AMENDMENT OF SOLICITATION/MODIFICATION OF CONTRACT

0004

DAAE20-03-T-0371

DESIGN ACTIVITY	U.S. ARMY ENGINEERING CENTER FLEXIBLE STAMP
DATE	03-07-07
DESIGNER	BONAVITO
CHECKER	BONAVITO
APPROVER	
SCALE	NONE
SHEET	1 OF 1
UNIT	IN
PROJECT	TUBE BODY FOR 12x56 MULTIPLE ROUND CONTAINER.
STOCK	304
D	81361
MATERIAL	M1256004

<u>List of Addenda</u>	<u>Title</u>	<u>Date</u>	<u>Number of Pages</u>	<u>Transmitted By</u>
Attachment 003	DRAWING M1256004	07-JUL-2003	001	DATA

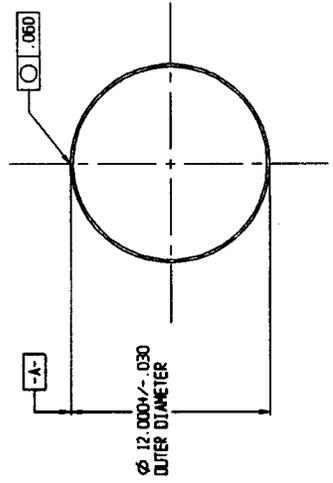
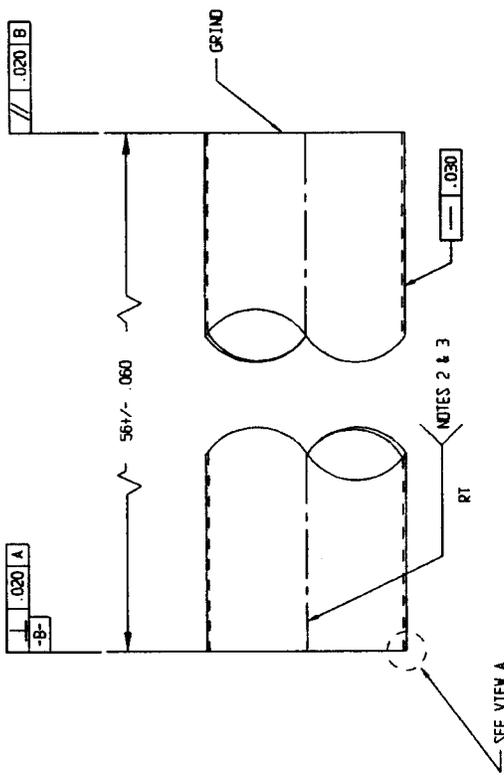
- a. Subject solicitation is hereby extended as stated in Block 11.
- b. Contractors shall revise and submit their offers to change from Specification A554, entitled Standard Specification for Welded Stainless Steel Mechanical Tubing, to Specification A269, entitled Standard Specification for Seamless and Welded Austenitic Stainless Steel Tubing for General Service.
- c. Drawing M1256004 is hereby incorporated and attached.
- d. Prospective contractors shall acknowledge this amendment and return one copy, including the enclosed Schedule B, to the issuing office. Revised offers shall be submitted in accordance with Clause 61, Federal Acquisition Regulation (FAR) 52.215-4510 TACOM-RI, Electronic Bids/Offers.

- THIS DRAWING SHALL BE INTERPRETED IN ACCORDANCE WITH APPLICABLE STANDARDS LISTED IN 000-STD-100. ANSI Y14.5-DATED 1994 APPLIES. AWS 2.4-86 APPLIES.
- MATERIAL: 304 STAINLESS STEEL 10 GAUGE. ROUND TUBING PER ASTM A554-94 OR ASTM A269-02a. ELECTRIC RESISTANCE WELDED. PLANISH TO FLATTEN WELD BEAD.
- RADIOGRAPHIC INSPECTION OF SEAM WELD WILL BE IN ACCORDANCE WITH ASTM E309-95 GRADE 2 AND MIL STD 453c-1988.
- REMOVE BURRS AND BREAK SHARP EDGES .016 INCHES.
- TOLERANCES ON STOCK MATERIAL SIZES SHALL BE AS SPECIFIED IN VENDOR SPECIFICATIONS.
